BLUE BIRD

Grid Heater Solenoid Mounting Modification

BULLETIN

Models Affected: 2010 BBCV with Cummins Engine

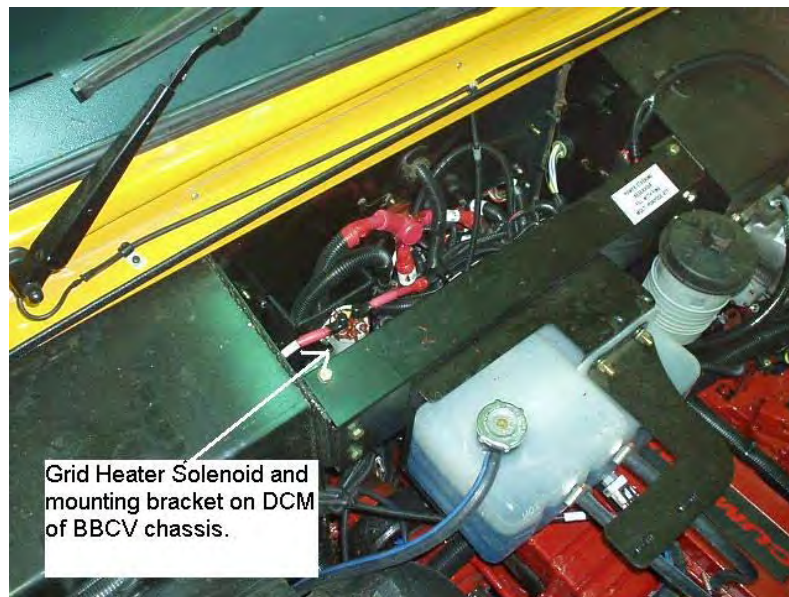
The grid heater solenoid power cable may contact the edge of the PDU bracket and/or grid heater solenoid mounting bracket screws.

Remove and re-orient grid heater solenoid mounting bracket screws. Also install vinyl edge guard trim on top edge of solenoid mounting bracket

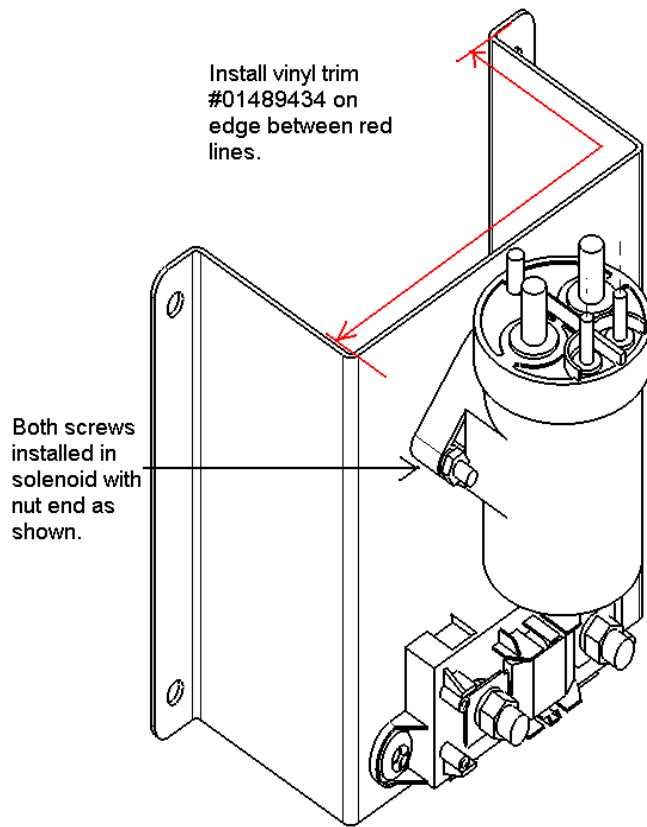
4. Use a Phillips head screw driver and 3/8 inch wrench to remove both screws from the flanges of the grid heater solenoid. Then reinstall the existing screws with the threaded (nut) end reversed, out toward the flange on the solenoid as shown in diagram on page 2. Tighten nuts securely.

5. Install vinyl edge trim 01489434 along the edge of solenoid mounting bracket as shown above.
6. Inspect cables and loom for any damage from screw thread and bracket edge. If any damage exists, contact Blue Bird Recall Administrator.
7. Reconnect batteries – Note, when connecting the batteries, connect the Positive cable first.
8. Perform Post Rework Inspection Steps as listed on page 3.
